DIREZIONE
ASSISTENZA CLIENTI

**INFORMATION SHEET
IMPROVEMENT BULLETIN
TECHNICAL BULLETIN**

up to 31st May 1967

CONTENTS

GIULIETTA, GIULIA and "2600" Models WITH FLOOR MOUNTED GEARSHIFT LEVER

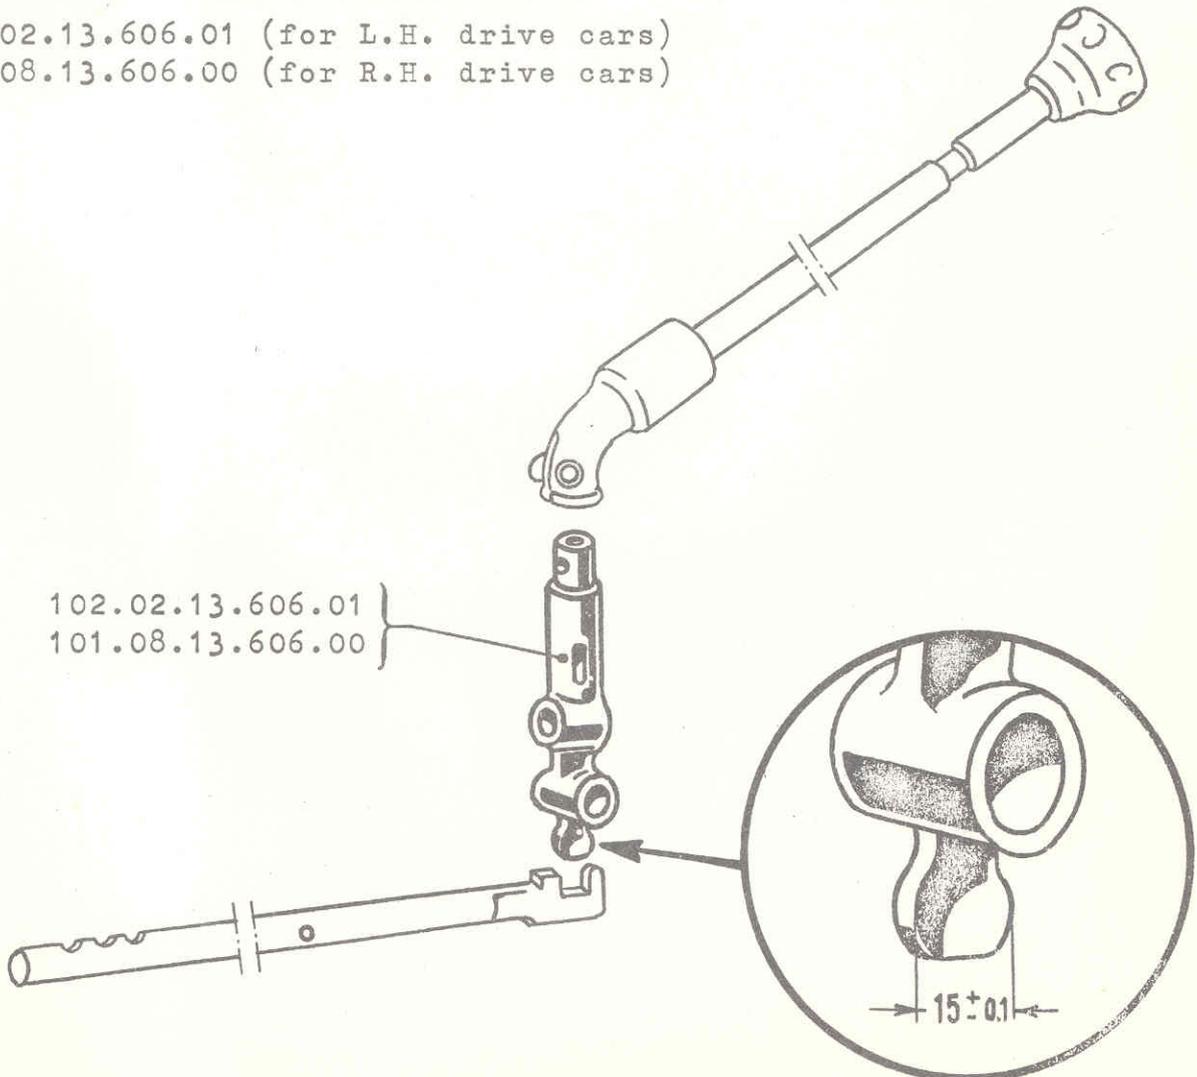
This sheet is to notify the modification introduced to the gearshift lever inner swivel whose finger spherical diameter has now been reduced to $15 \pm .1$ mm ($.5905 \pm .0039$ "). See figure.

If excessive vibration is felt in the floor mounted gearshift lever on some of the above mentioned models, it is advisable to replace the inner swivel with modified finger for the old swivel.

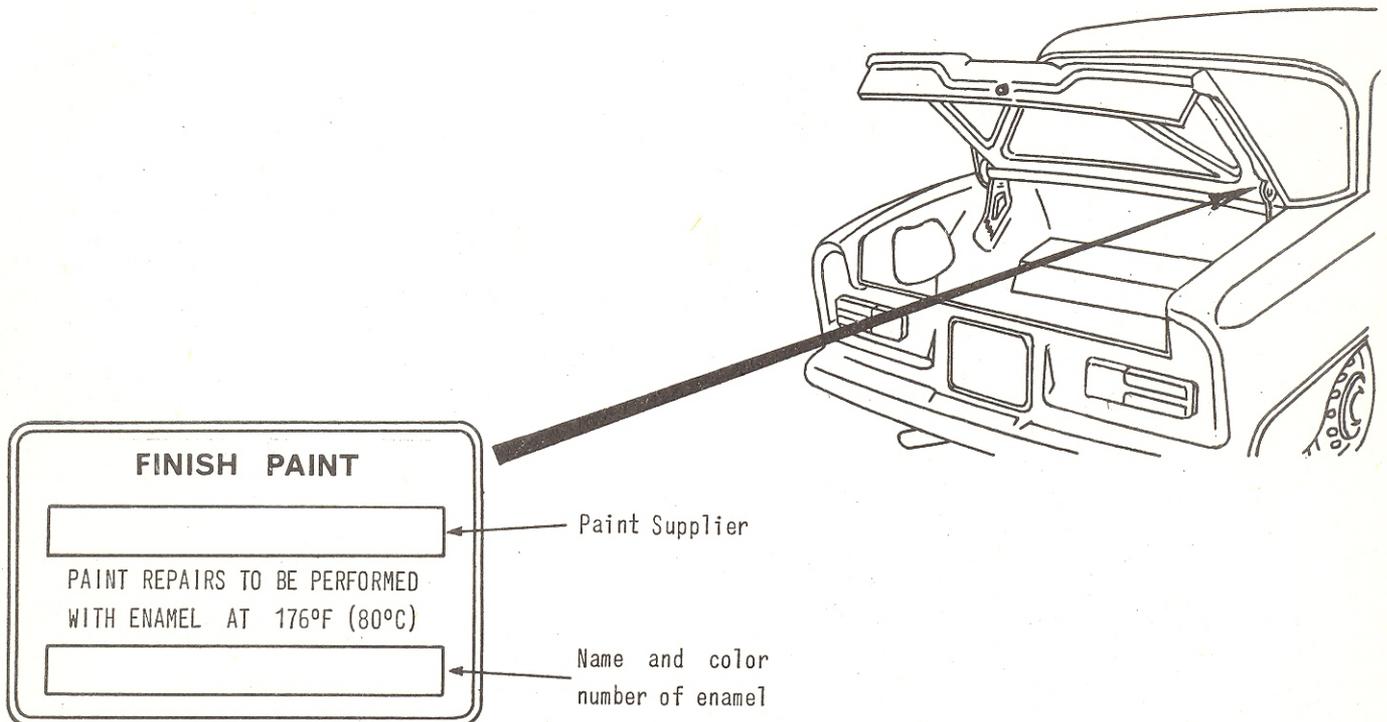
The plate, like that shown below, identifying the type of paint used for car finish has been moved from within the engine compartment to the luggage compartment. When performing paint repairs, to order the corresponding paint, quote the data given on the plate.

You can find it on the lid, R.H. bottom, next to the lid hinge.

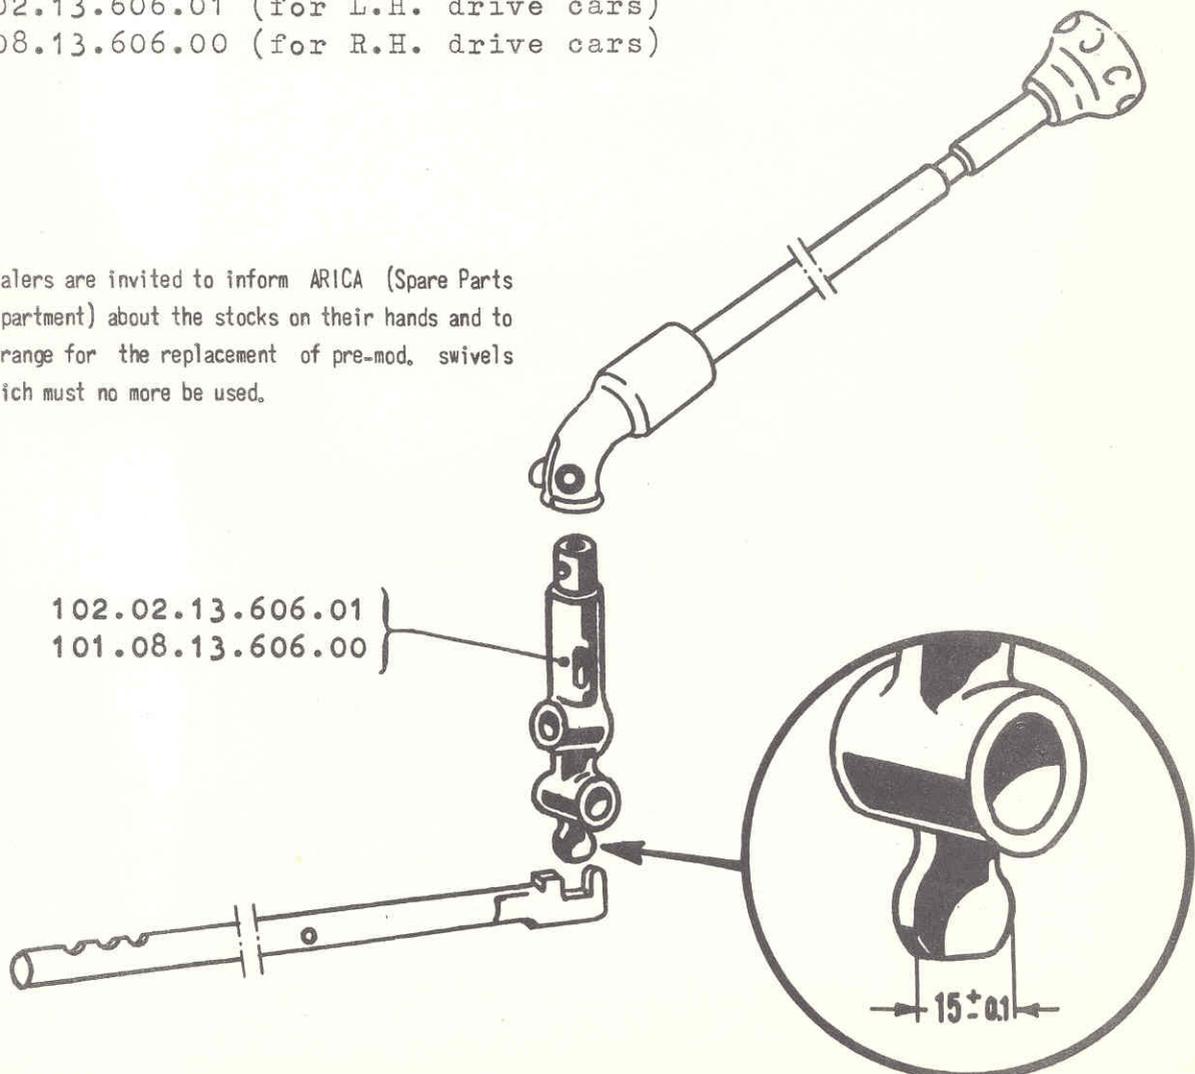
This sheet is to notify the modification introduced to the gearshift lever inner swivel whose finger spherical diameter has now been reduced to $15 \pm .1$ mm ($.5905 \pm .0039$ "). See figure.

If excessive vibration is felt in the floor mounted gearshift lever on some of the above mentioned models, it is advisable to replace the inner swivel with modified finger for the old swivel.

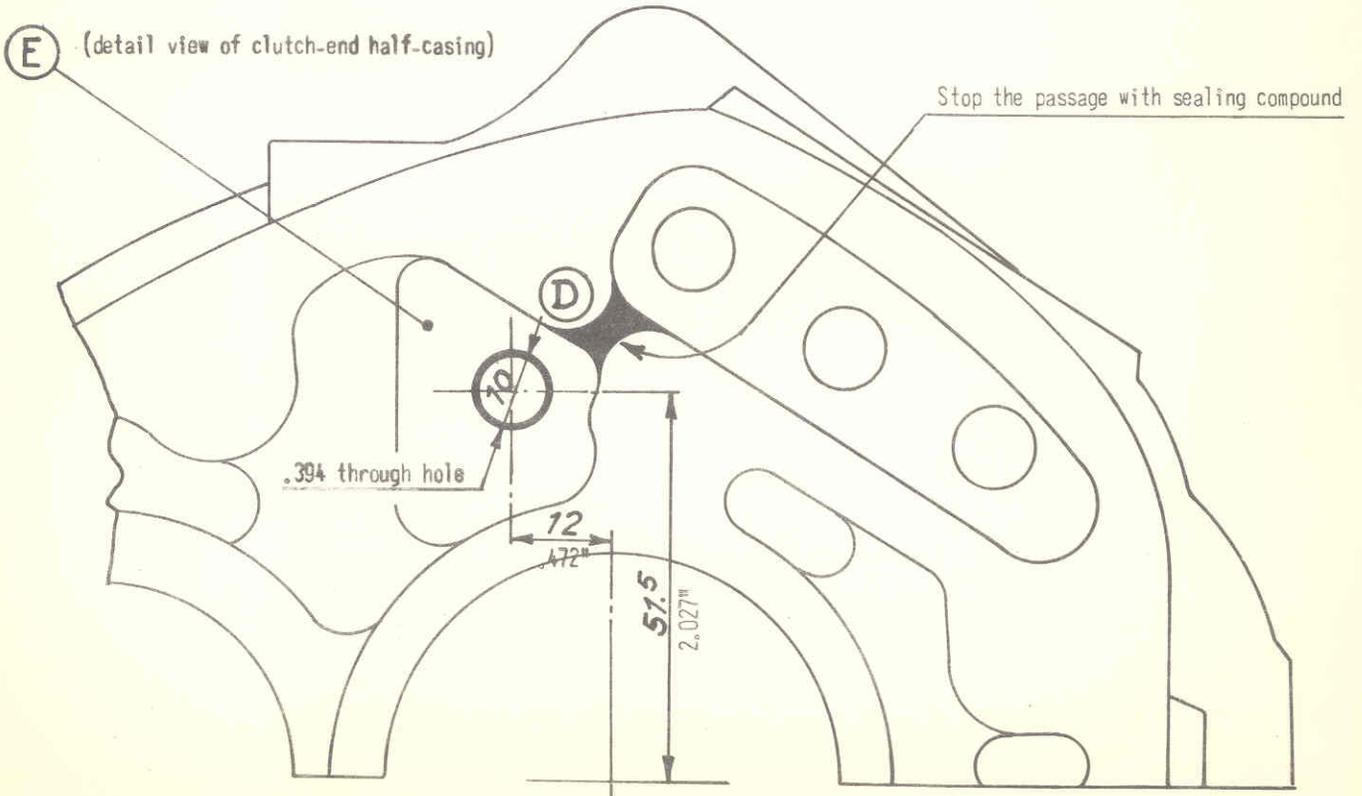
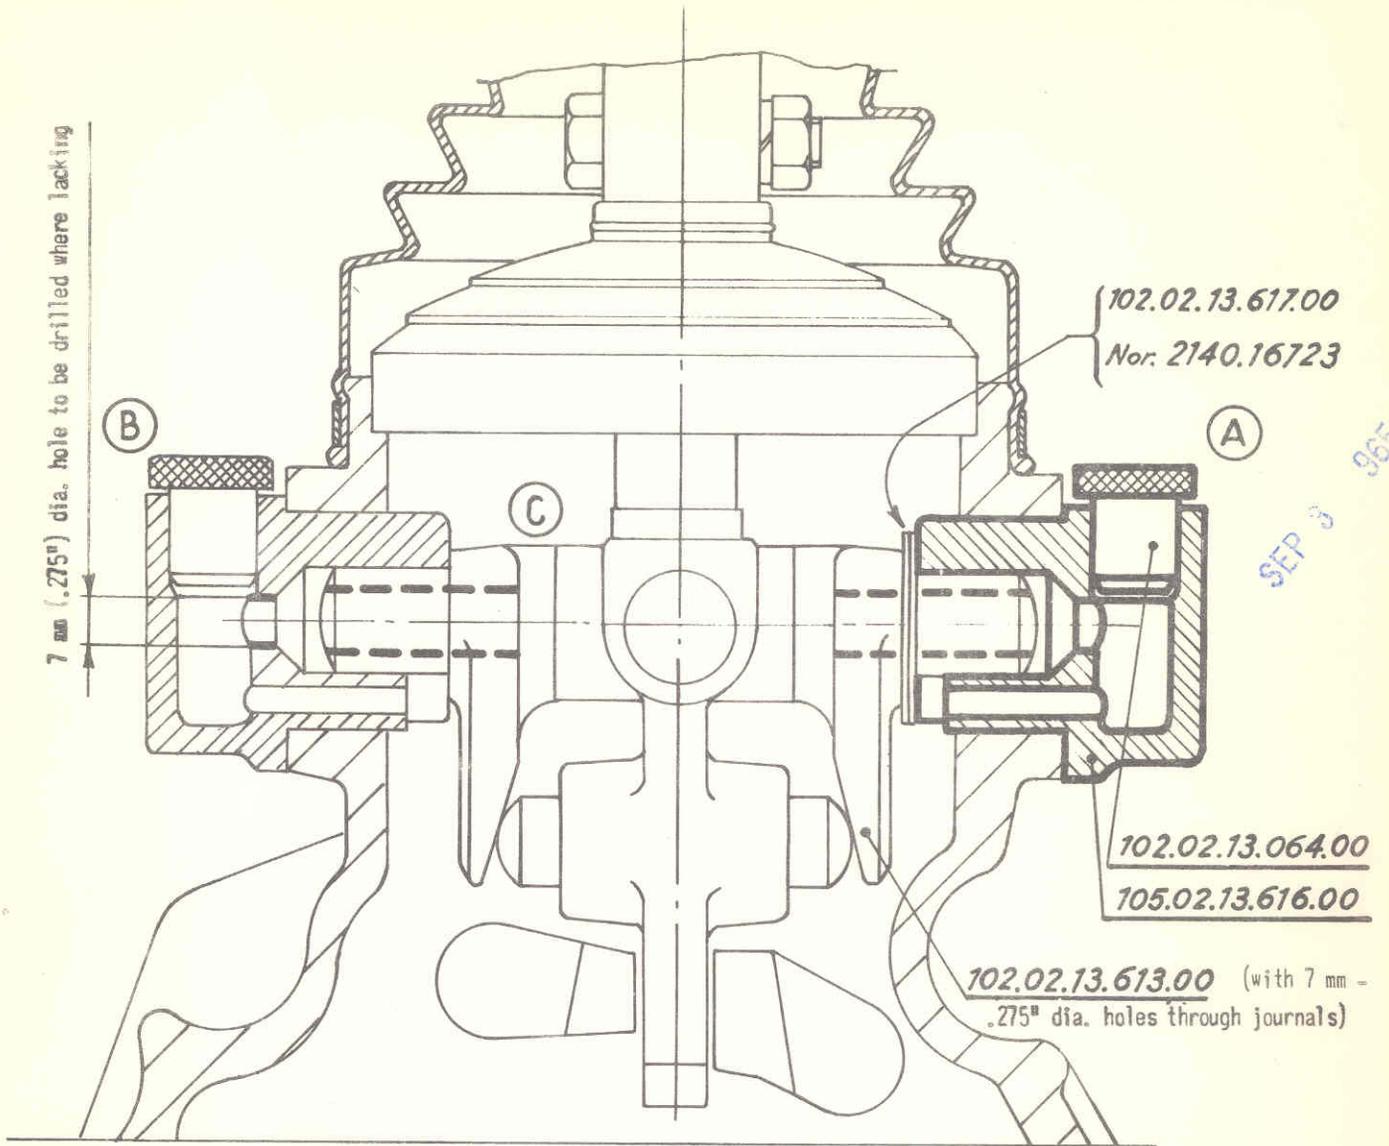
These modifications can be introduced in already released cars, which show oil leakage from the above mentioned components, proceeding as follows:

- a) carry out an additional vent hole (A) on the side opposite the existing hole (B);
- b) install the gearshift swivel (C) with through holes in the journals for connection of vent chambers with the inside of gearbox;
- c) stop the oil drain passage (D) which proves leaking oil under pressure;
- d) drill a hole 10 mm (.394") in diameter through the rib (E) to equalize the pressure on clutch-end bearing.

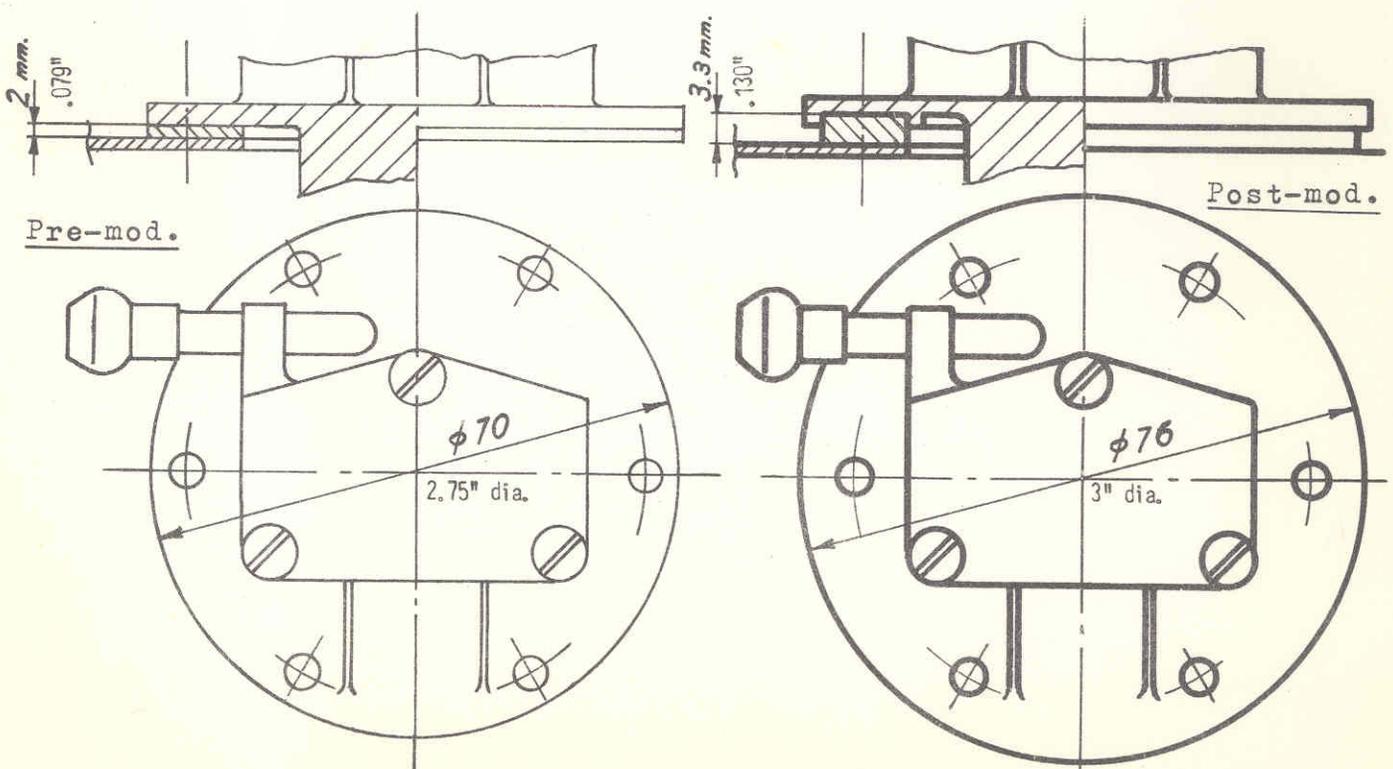
Also the thickness of sealing ring has been increased as follows:
 from 2 mm (.079") pre-mod. ring P.N. 1356.85.026
 to 3.3 mm (.130") post-mod. ring P.N. 105.14.32.502.00

For the already released cars provided with the post-mod. Jaeger gauge, recognizable by the larger flange diameter, it is advisable to replace the pre-mod. sealing ring with the post-mod. ring.

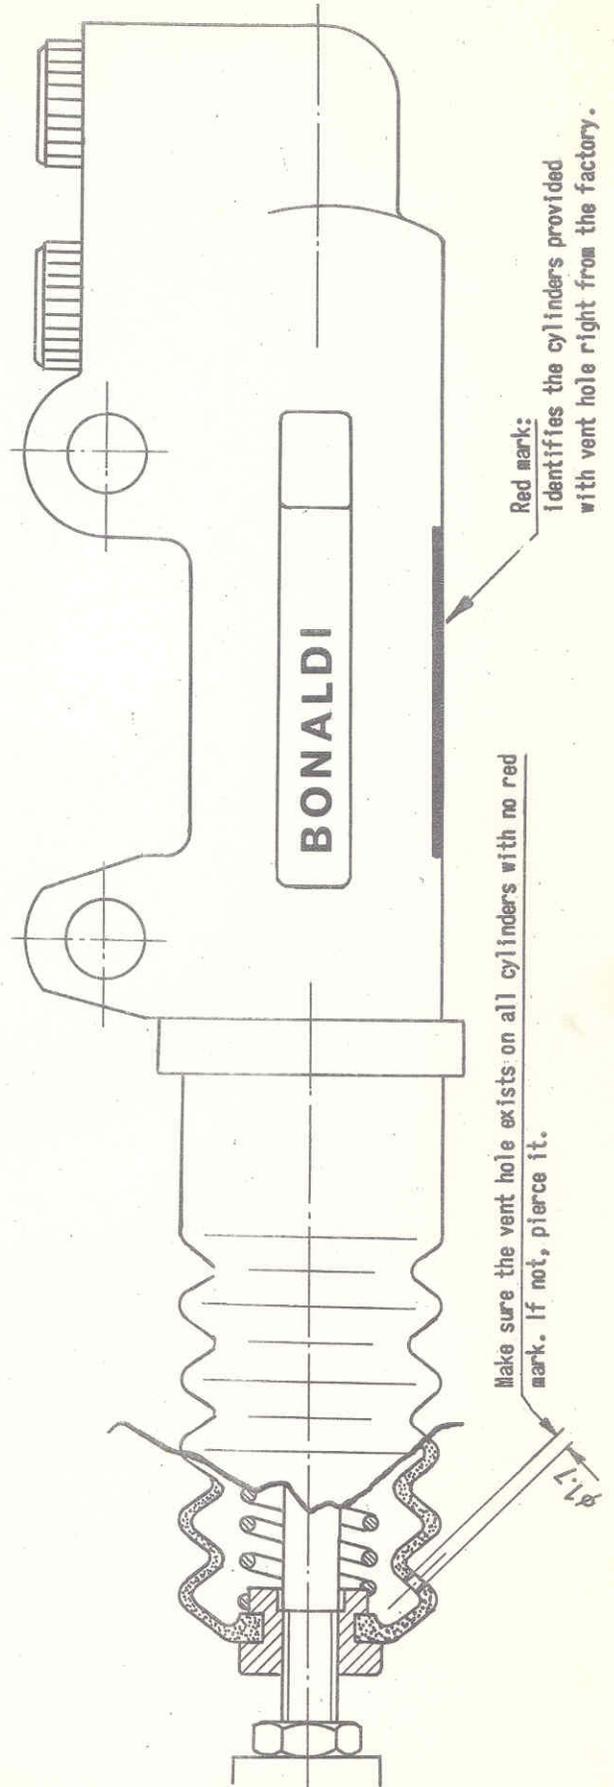
Therefore the master cylinders of all cars in circulation should be checked for the existence of such a vent hole and, where missing, the bellows should be pierced as shown through one wall only with a pin 1.5 mm (.06") in dia. previously heated to red hot.

Furthermore it is advisable, before piercing the vent hole, to inspect visually the cylinder bore and plunger surfaces for sound appearance. If they are corroded, replace the master cylinder assy with a new one.

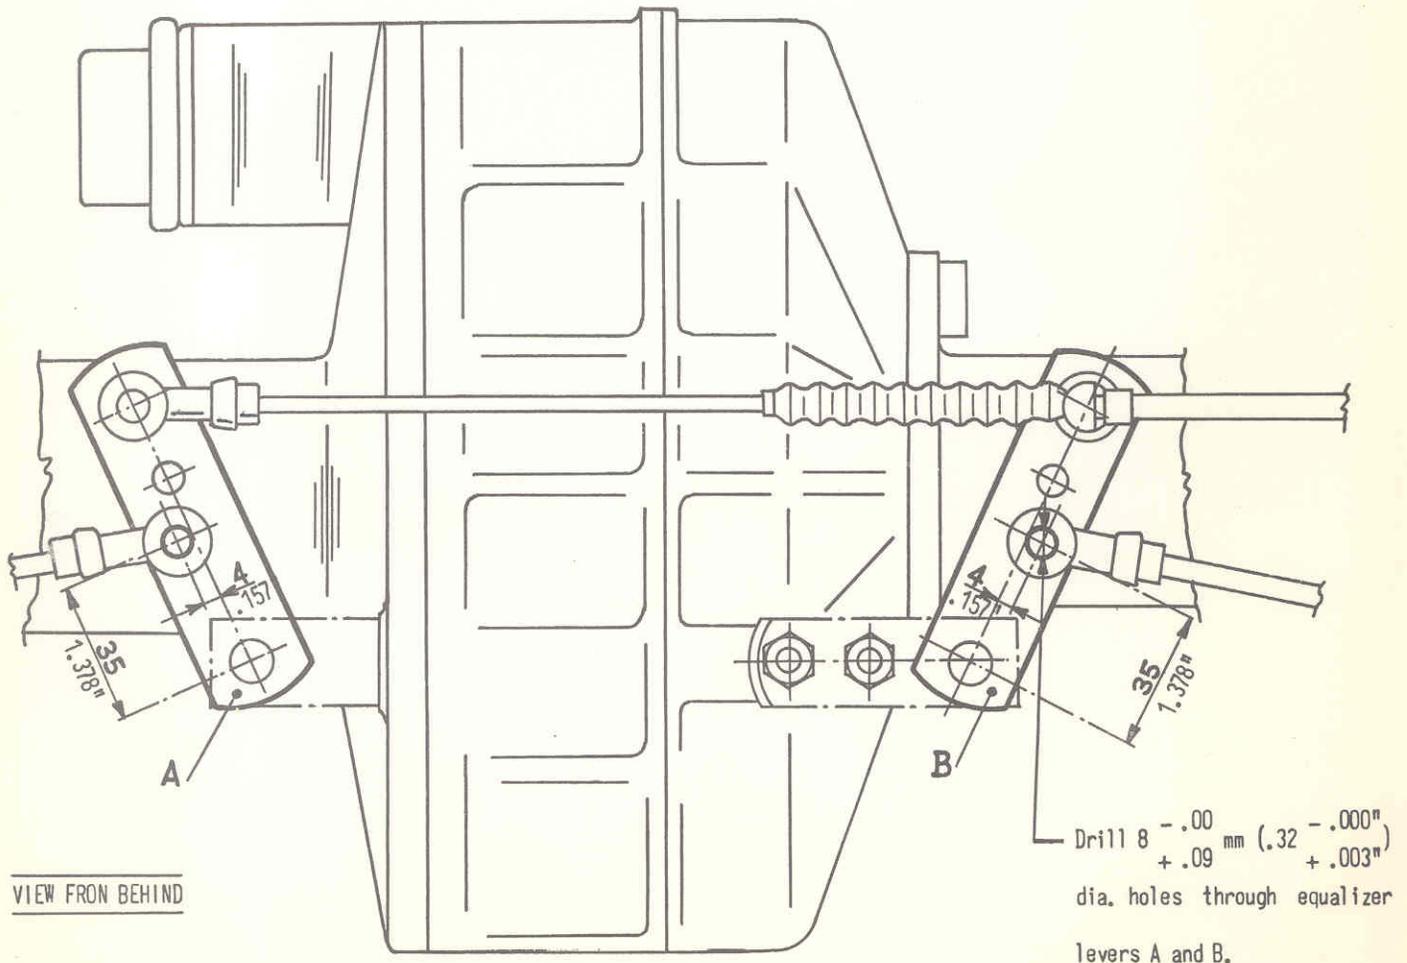
Should Customer complain of handbrake operation, the handbrake linkage can be modified as to increase the leverage. To do so, drill new holes in the equalizer levers as shown, and connect track cables there.
